STAFF REPORT
KETCHUM PLANNING AND ZONING COMMISSION
REGULAR MEETING OF JANUARY 13, 2020

PROJECT: My Sun Valley Home Property Services Mixed-Use Building

FILE NUMBERS: P20-003 & P20-004

APPLICATION TYPES: Design Review and Conditional Use Permit

FLOOR PLAN - THIRD LEVEL • 2,543 SF

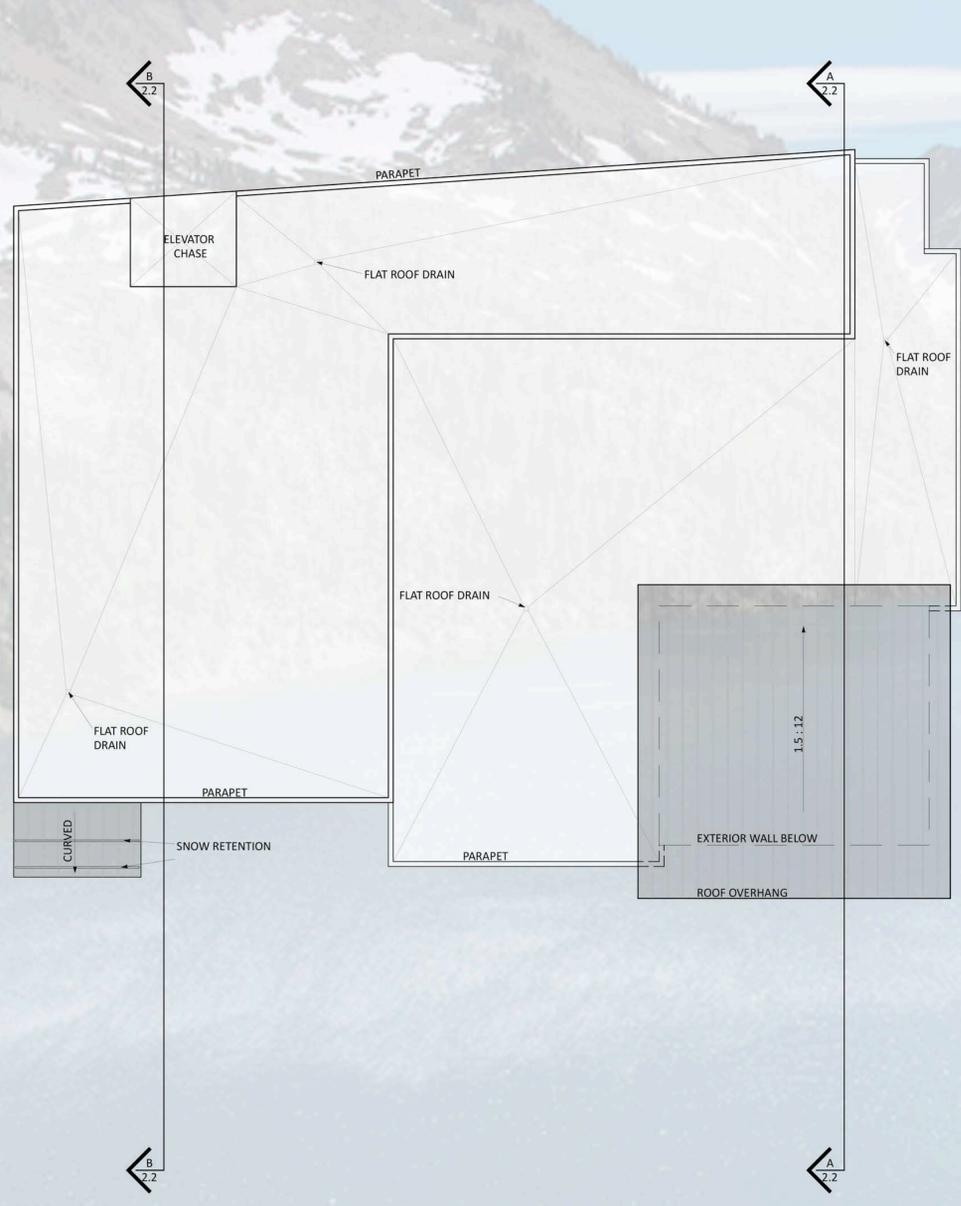
As indicated on Sheet 5 of the applicant submittal (Exhibit A), the third level of the building is reserved for three one-bedroom employee housing units. The housing units are accessed from a common lobby. Each unit has its own separate storage area and designated parking space. The employee housing units are subject to the minimum criteria for residential units in light industrial districts as specified in KMC §17.124.090.

WEST ELEVATION

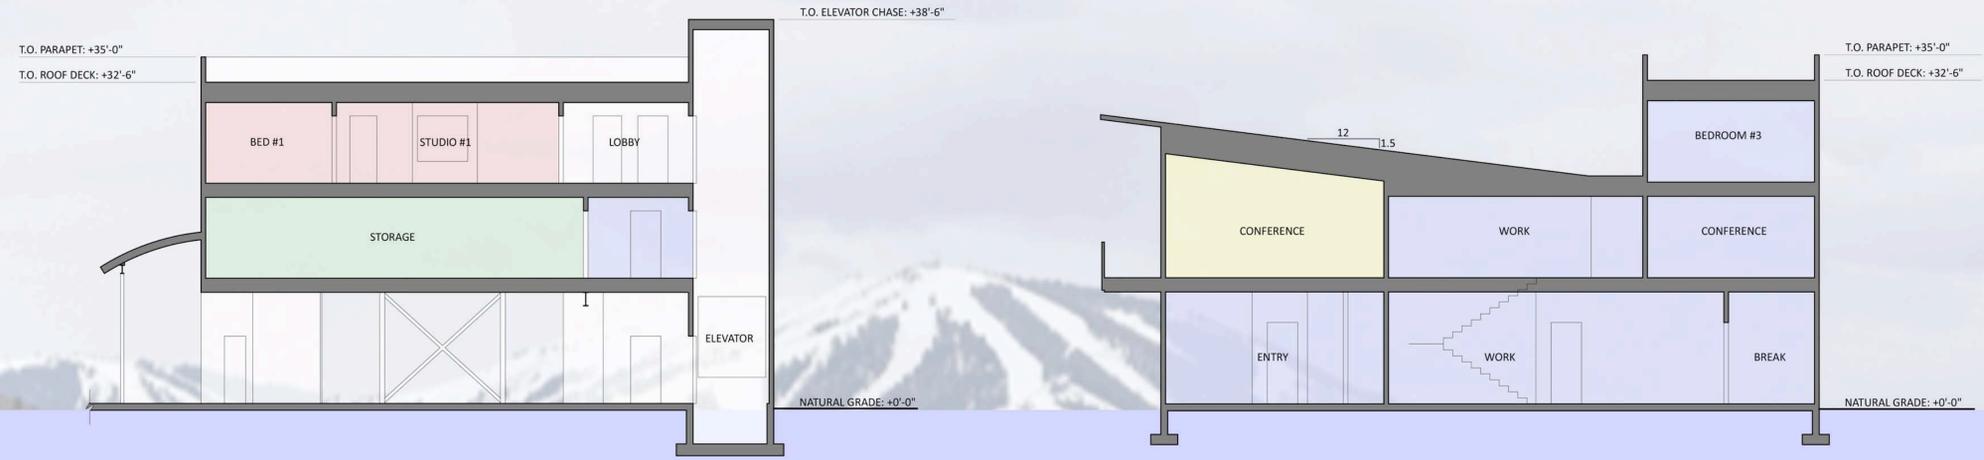
Staff Comments	<i>As indicated on the Material Board and Sheet 7 of the drawings, the proposed exterior materials include: (1) "weathered zinc" vertical standing seam siding, (2) prefabricated, light-gray stucco panels, (3) "rubi" Parklex wood siding panels, (4) corrugated galvanized guardrail panels with dark gray steel supports, (5) "hemlock" clad wood windows and doors, (6) brown fiberglass windows, (7) dark-gray, exposed steel beams and columns, and (8) red/brown gridded steel screening panels. The roof system is comprised of (1) "weathered zinc" standing seam metal roofing, (2) a white TPA flat roof system, and (3) curved corrugated galvanized roofing.</i>
				<i>The proposed design including the exterior materials and colors of the mixed-use building is complementary to other structures within the neighborhood. The gray stucco and wood siding panels combined with the exposed steel beams and columns echo the light industrial area's interaction with Ketchum's mountain backdrop and natural surroundings. Disparate from the flat roof system, the low pitch roof (1.5/12) element is highlighted as a distinguished feature that resonates with the architectural vernacular of the new, more modern development within the City of Ketchum.</i>

<input checked="" type="checkbox"/>	<input type="checkbox"/>	<input type="checkbox"/>	17.96.060.F5	Building walls shall provide undulation/relief, thus reducing the appearance of bulk and flatness.
			Staff Comments	<i>The proposed elevation views provided by the applicant show that all building walls provide undulation and relief, serving to reduce the appearance of bulk and flatness at all façades. The façades combine horizontal and vertical elements through the variation of siding materials, the placement of balconies and associated railings, the garage doors, as well as the fenestration provided through multiple window and door openings. The main entrance is distinguished by the low pitch roof and the overhang of the second-level balcony. Breaks are incorporated into the vertical wall plane through recessed building masses and projecting elements, which articulate the each and reduce the appearance of flatness.</i>

PLANT PALETTE

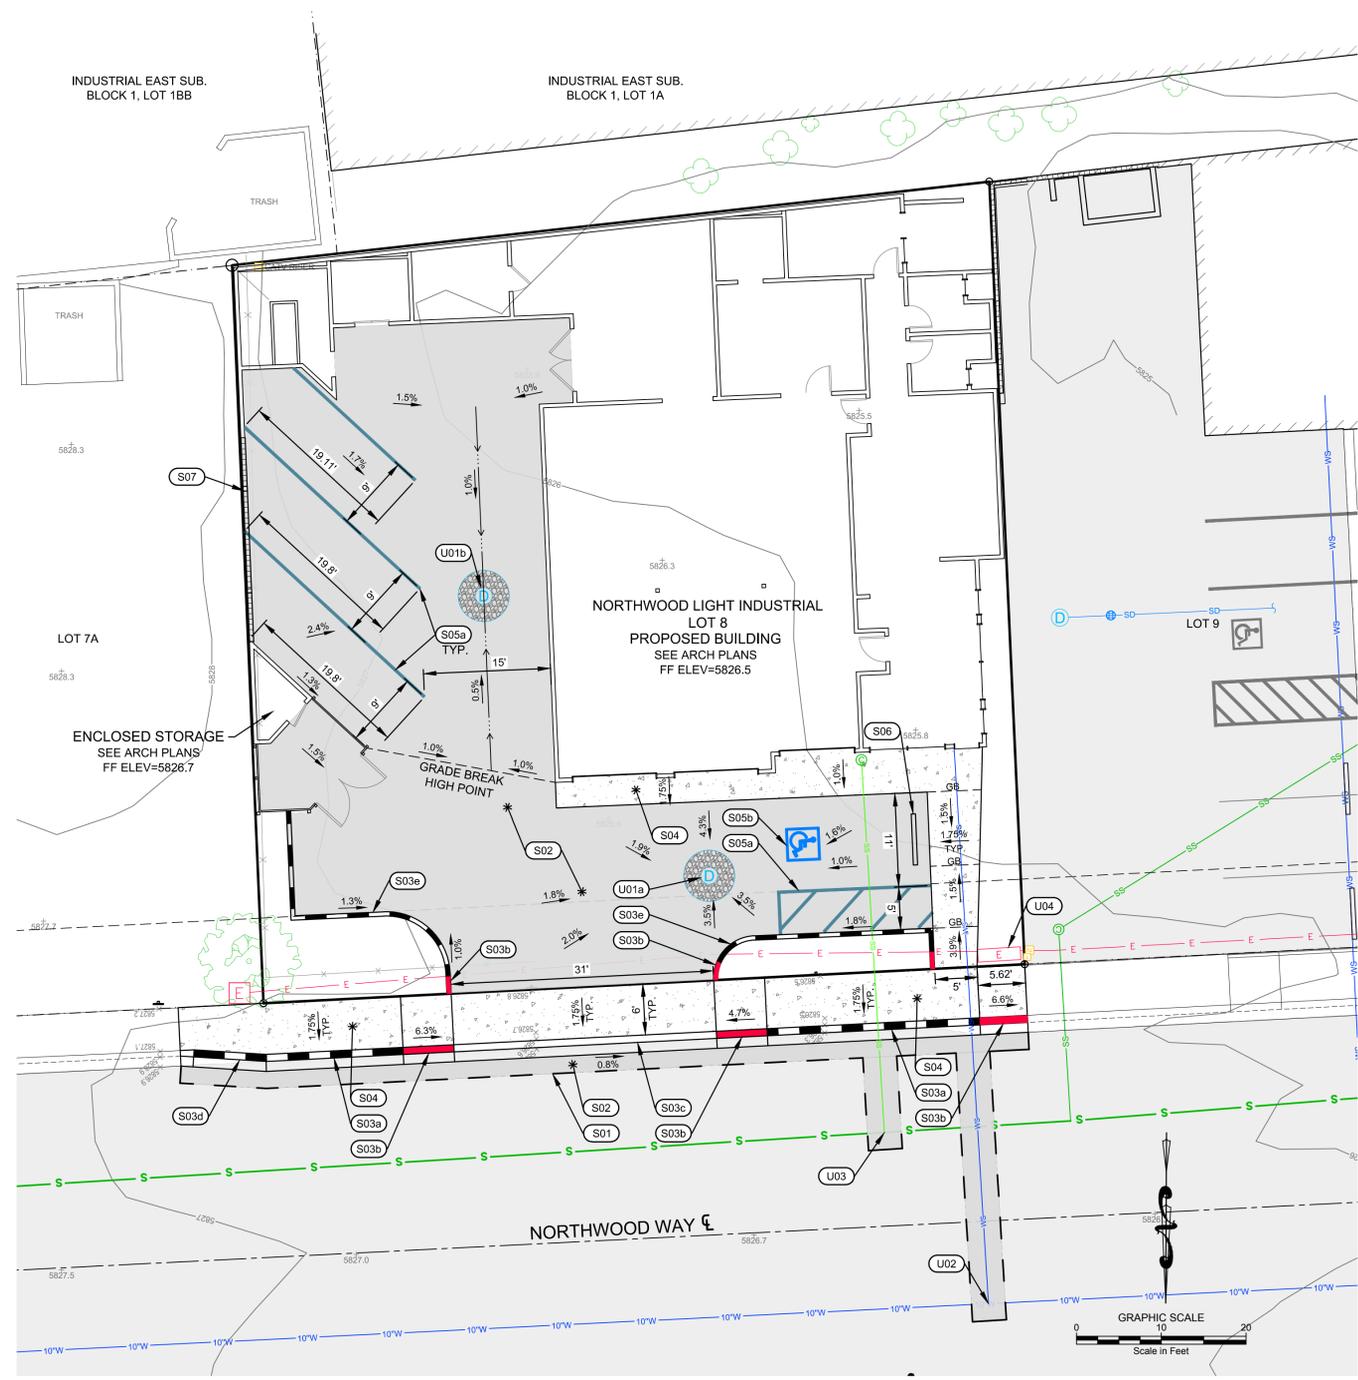
Staff Comments	<i>The landscape plan is included on Sheet L1.0 of the submittal drawings. The landscape plan includes Swedish aspens as well as planters comprised of ornamental grasses and perennial flowers.</i>
<input checked="" type="checkbox"/>	<input type="checkbox"/>	<input type="checkbox"/>	17.96.060.I2	Landscape materials and vegetation types specified shall be readily adaptable to a site's microclimate, soil conditions, orientation and aspect, and shall serve to enhance and complement the neighborhood and townscape.
			Staff Comments	<i>The landscape materials and vegetation types shall be readily adaptable to the site's microclimate, soil conditions, orientation, and aspect. The proposed landscaping will soften the mass of the mixed-use building and enhance the neighborhood. Bordering the front property line, the planters framing the driveway access create an inviting entryway to the mixed-use development.</i>
